INSPECTION REPORT
Sedimentation Structure
J7-G
Black Mesa Mine
Navajo County, Arizona

for
PEABODY COAL COMPANY

Dames & Moore
10139-011-22

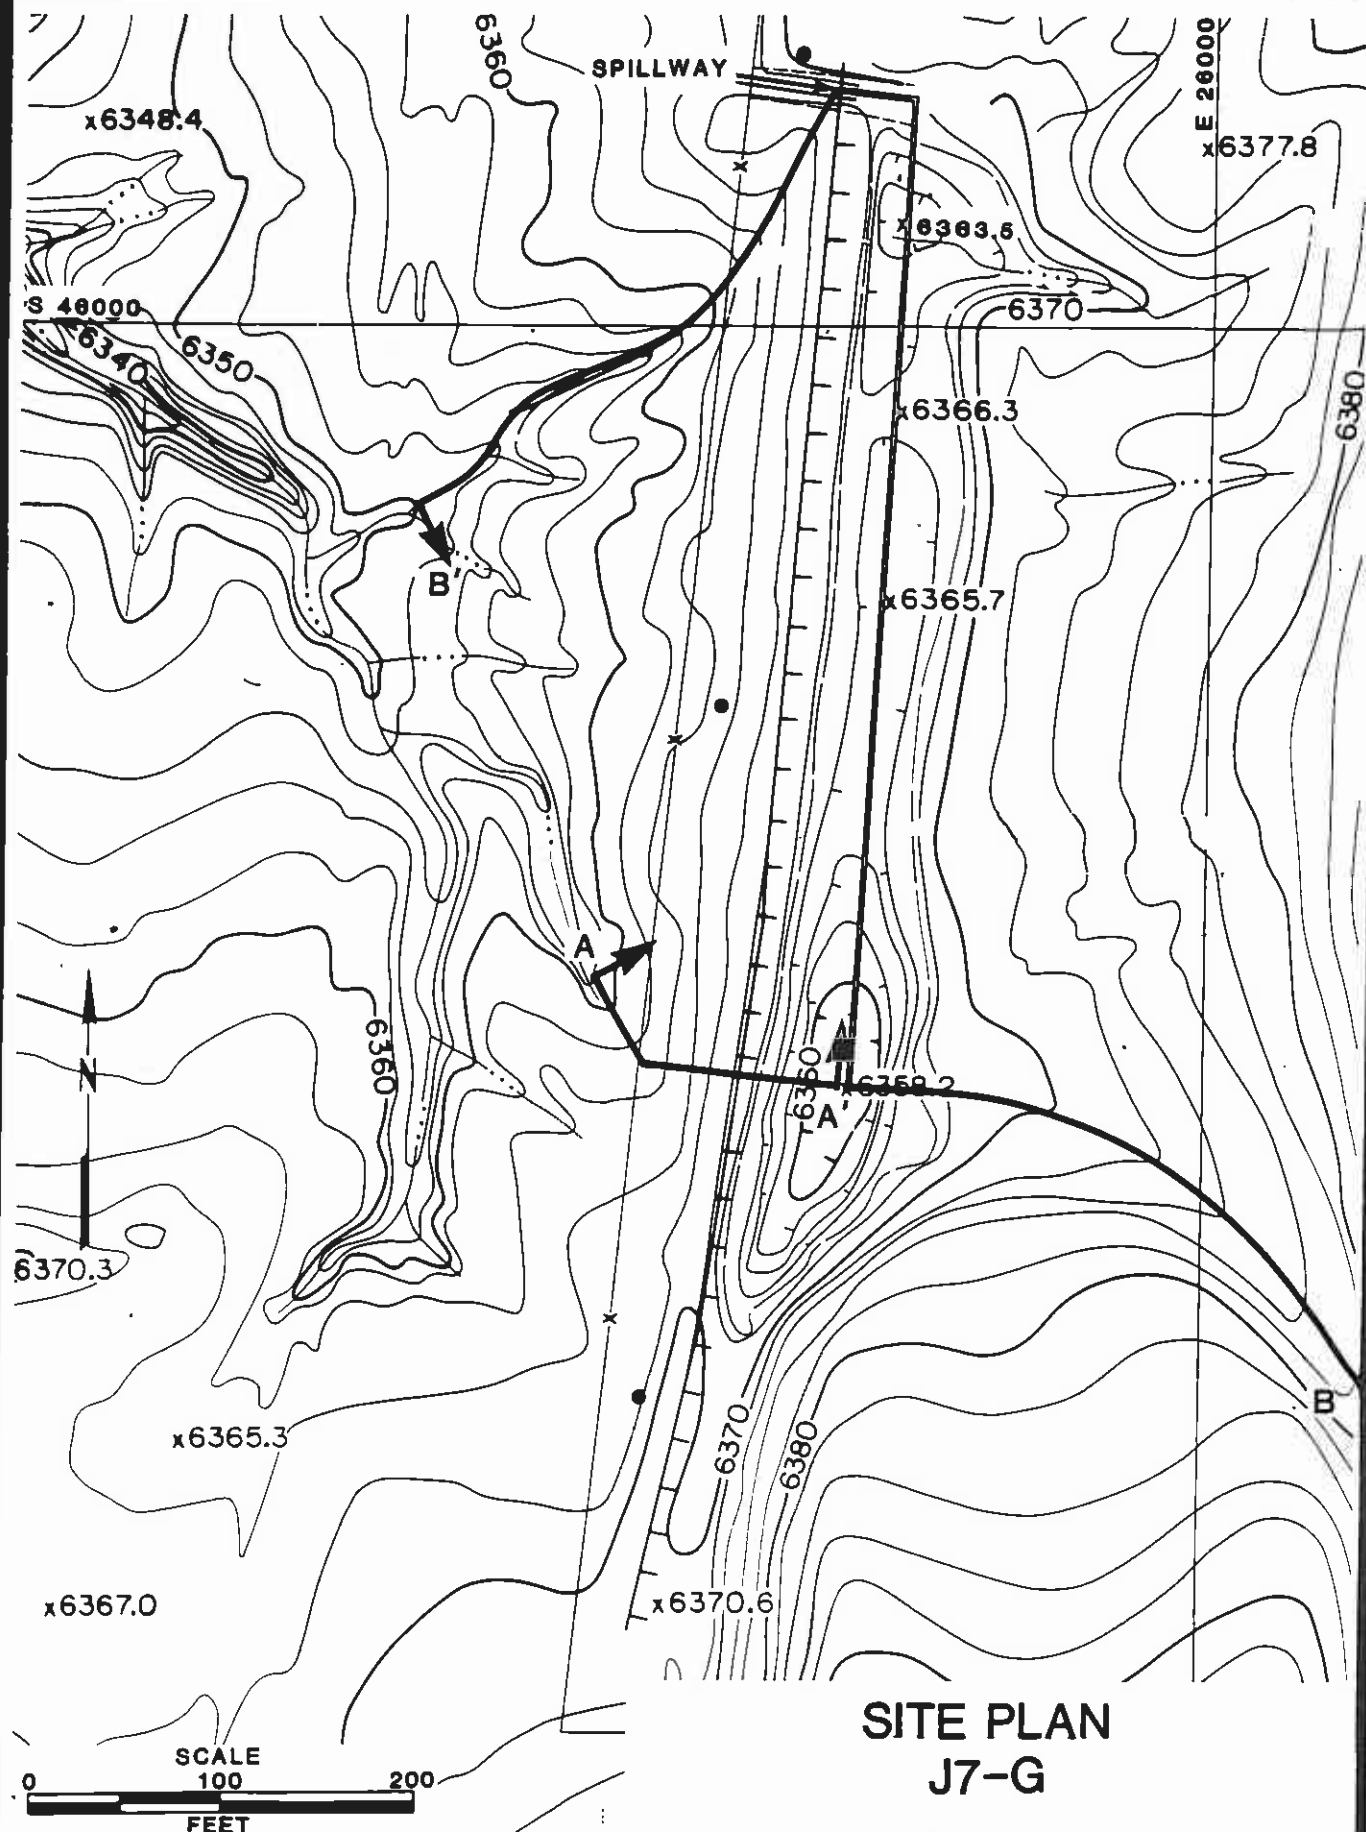
Dames & Moore's evaluation indicates that the storage and spillway capacity of Structure J7-G are adequate; however, the spillway does not have an outflow channel nor adequate erosion protection. A trapezoidal outflow channel should be constructed along the alignment B-B' shown on Plate 1. The channel profile is shown on Plate 4 and the required dimensions are shown on Plate 5. Both the spillway and outflow channel should be protected against erosion using geotextile and gravel as shown on Plate 5.
